<b>Docket Number:</b>	17-BSTD-01
<b>Project Title:</b>	2019 Building Energy Efficiency Standards PreRulemaking
<b>TN #:</b>	220512
<b>Document Title:</b>	Philips Lighting Comments on draft CASE Report NR Outdoor Light Sources
<b>Description:</b>	N/A
<b>Filer:</b>	System
<b>Organization:</b>	Philips
<b>Submitter Role:</b>	Public
<b>Submission Date:</b>	8/2/2017 12:20:43 PM
<b>Docketed Date:</b>	8/2/2017

**Philips Lighting Comments on draft CASE Report NR Outdoor Light Sources**

**Philips Lighting Comments on the Draft CASE Report (June 2017) NR Outdoor Light Sources for the 2019 California Building Energy Efficiency Standards, California Code of Regulations, Title 24, Part 6**

Figure 2: LRC Webinar: Response to the American Medical Association Report “Human and Environmental Effects of Light Emitting Diode Community Lighting” March 2017, slide 21

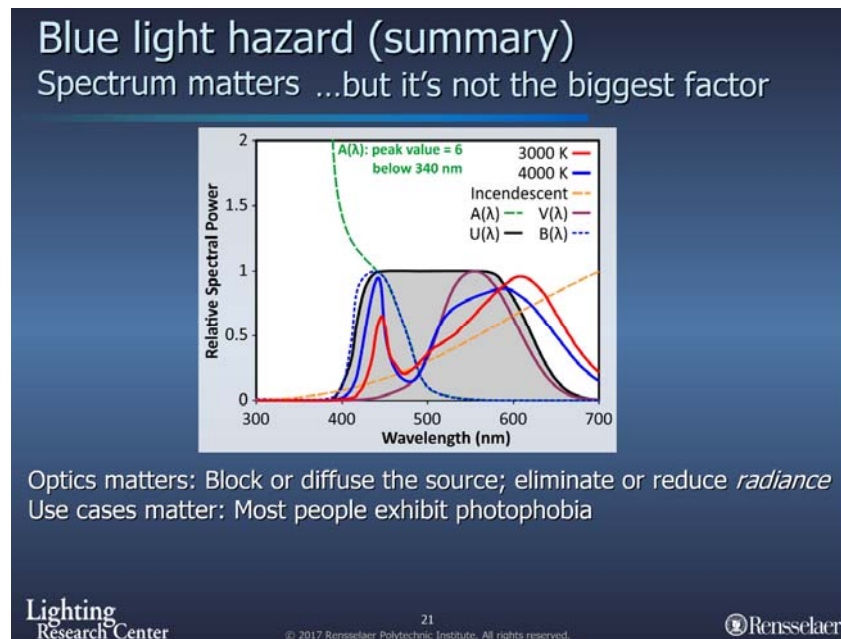
The highlighted lines are representative of what is in the American Medical Association study. The data shows that a person would have to stare at the 3000 K source for 43 minutes and the 4000 K source for 33 minutes respectively to incur damage to the eyes. Also important is that the Permissible Exposure Times indicated by the AMA study and shown in Figure 1 above are for an LED source that is 0.5 meters (1.6 feet) from the face. This is an unlikely scenario for an outdoor lighting application.

Because research is ongoing and the amount of light, duration and timing of exposure, and spectrum all matter, we believe it is premature to limit the scope of possibilities for outdoor lighting based solely on the correlated color temperature of the light source.

California building owners and those who design and install outdoor lighting should be allowed to select outdoor lighting of various CCTs provided the lighting is highly efficient, safe, limits the wasting of energy, and meets established luminaire cutoff requirements to prevent urban pollution, skyglow, and light trespass.
